BTT Automatyka	REGULATED COOLING SYSTEM FOR DIESEL ENGINE .	cooling system ORIGO 19 XI 2026	Projekt: Andrej	Nr rysunku:	Nazwisko: / Modyfikacja: / Schemat: 1
			Data: 18.11.2026	Funkcja: / Lokalizacja:	Lb. sch: 6 / Sch. nast: 3

ORIGINAL COOLING SYSTEM

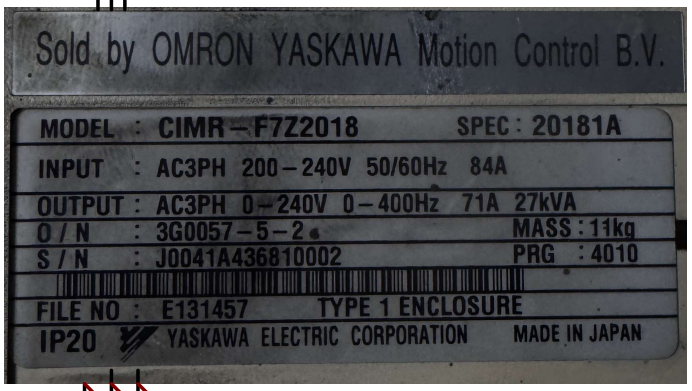
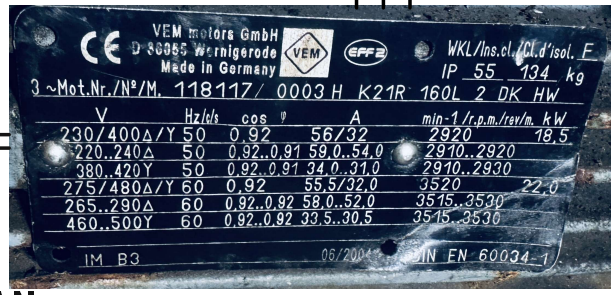
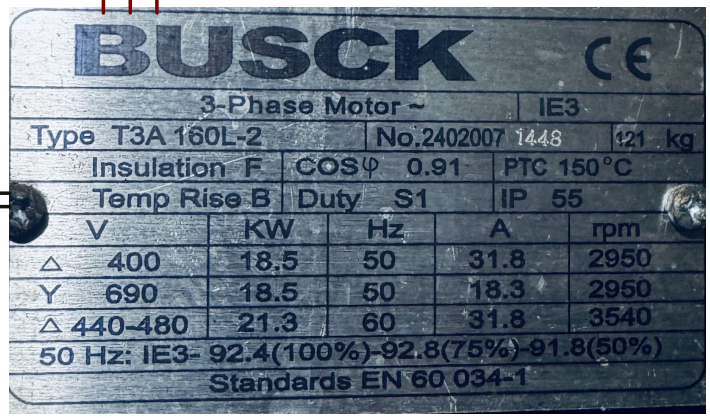
THE GRID ON THE VESSEL IS 3X220VAC

BAD AC MOTOR COOLING SYSTEM

3X220 VAC SHOULD BE 3X400 VAC

THIS MOTORREQUIRES 3X400VAC SUPPLY.

TWO WAYS TO REPAIR :

1 - NEW INVERTER 3x220VAC AND REPAIR OF THE PUMP BLOWER

2 - PURCHASE OF THE TRANSFORMER 220/400VAC AND NEW INVERTER
